# Work Order ID 79668

Item Name: Crosstube Assembly, Mid-Aft

DART AEROSPACE LTD HAWKESBURY, ONTARIO, CANADA	
DRAWING NO. D206-667-247	REV. A
TITLE CROSSTUBE ASS'Y (206L MID AFT)	SHEET 1 OF 4
SCALE NTS

DRAWING NO. D206-667-247	TITLE CROSSTUBE ASS'Y (206L MID AFT)	REV. A	<b>DART AEROSPACE LTD ENGINEERING ORDER</b>		D.E.O. NO. D206-667-247-A-1	SHEET NO. SHEET 1 OF 1	SCALE NTS
DRAWN <i>q2</i>	CHECKED <i>ASS</i>	MFG. APPR. <i>KD</i>	APPROVED <i>UMP</i>	DE APPR. <i>th</i>			
DATE 11.07.15	DATE 11.07.20	DATE 11.07.21	DATE 11/07/21	DATE 11.07.21

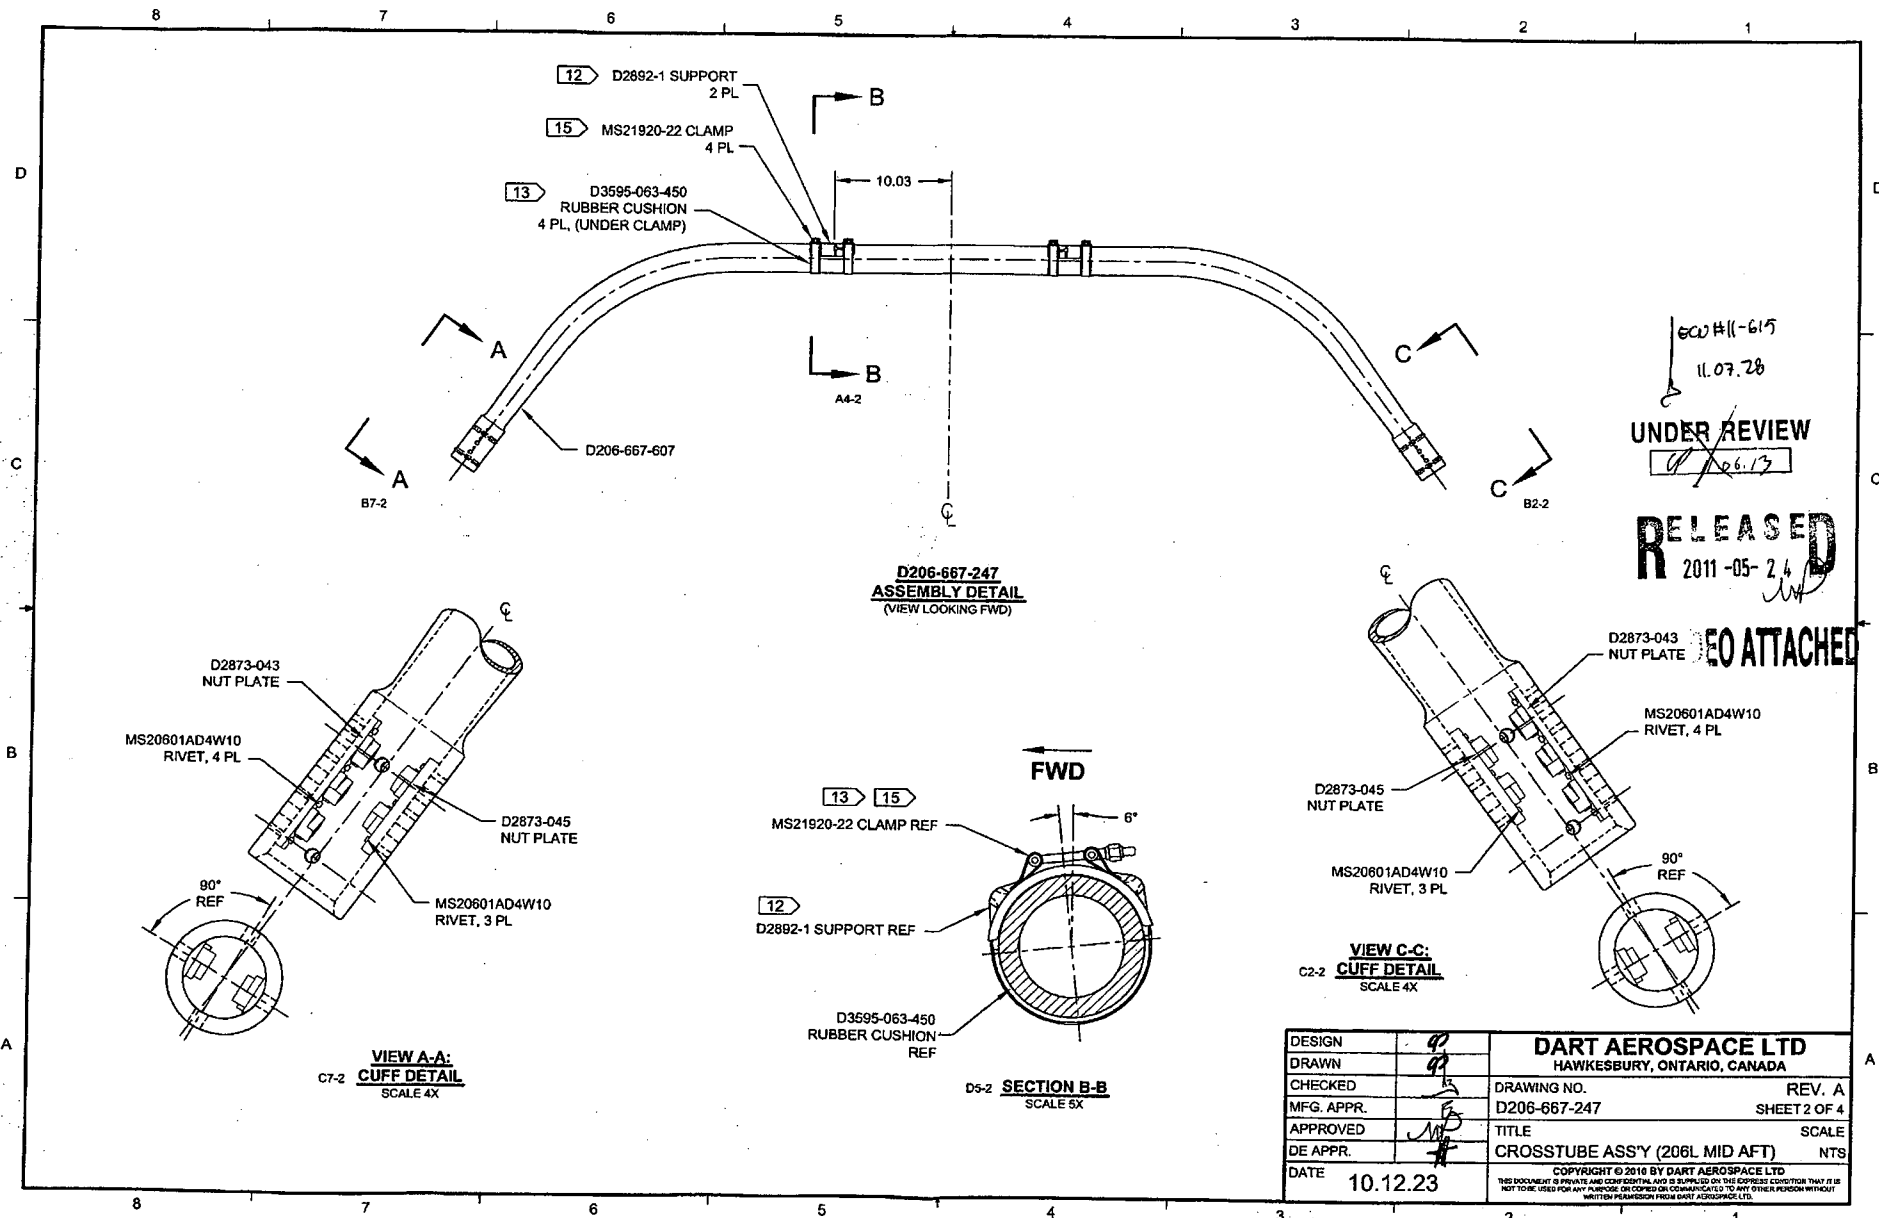
REPLACE MAGNOBOND WITH PROSEAL

NOTE 12 & 15, SHEET 1 IS AMENDED AS FOLLOWS:

- 12) TO INSTALL D2892-1 SUPPORT: ABRASE MATING SURFACE OF SUPPORT AND CROSSTUBE WITH 180-GRIT SANDPAPER AND REMOVE RESIDUE WITH MEK (OR EQUIVALENT). APPLY A 0.04" TO 0.07" THICK LAYER OF PROSEAL 890 CLASS B-2 (OR AMS-S-8802 CLASS B-2) SEALANT TO MATING SURFACE OF SUPPORT.
- 15) TORQUE CLAMPS 80 TO 100 IN-LB. ENSURE AT LEAST 1.5 THREADS SHOWING IN SAFETY AND THAT NUT HAS NOT BOTTOMED-OUT AFTER TORQUING. **PRIOR TO PACKAGING, RE-CHECK TORQUE ON CLAMPS AFTER PROSEAL 890 SEALANT HAS CURED FOR 72 HOURS.**
